LATHAN · McKEE
ARCHITECTS

ADDENDUM NO. 4
NEW BUS SHOP FOR BLOUNT COUNTY SCHOOLS
Architect Job No. 25-46
March 16, 2026
DCM #2026084

M1.2

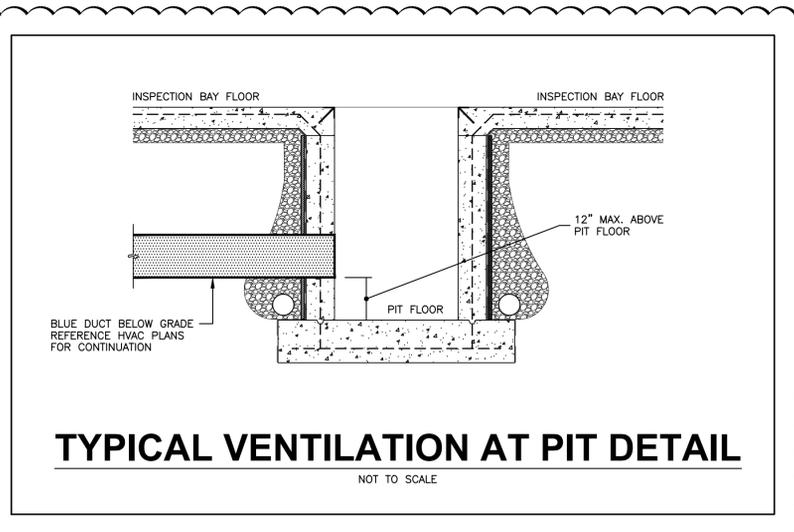
1. **See Sheets M1.1, M1.2, M1.3 and M3.1.**
Add supply fan (SF-1), exhaust fan (EF-6), louvers (L-5 & L-6, carbon monoxide detectors, associated duct, details, etc. as indicated by the revisions clouded on the attached sheets for pit ventilation.
2. **See Sheet E4.1**
The clouded revisions pick up the power being added for the new supply and exhaust fans in the pit.

MARK NO.	MOUNTING	CFM	STATIC IN W.G.	SONES	WATTS	VOLTAGE	MANUFACTURER (OR APPROVED EQUAL)	MODEL NO.	WEIGHT (LBS.)	NOTES
SF 1	INLINE	425	0.35	3	165	115-1-60	LOREN COOK	GN-720	34	SEE BELOW

- ① FAN TO INCLUDE FACTORY MOUNTED/PRE-WIRED FAN SPEED CONTROL.
- ② FAN TO BE SWITCHED WITH EXHAUST FAN EF-6
- ③ FAN TO INCLUDE FACTORY DISCONNECT AND DAMPER.
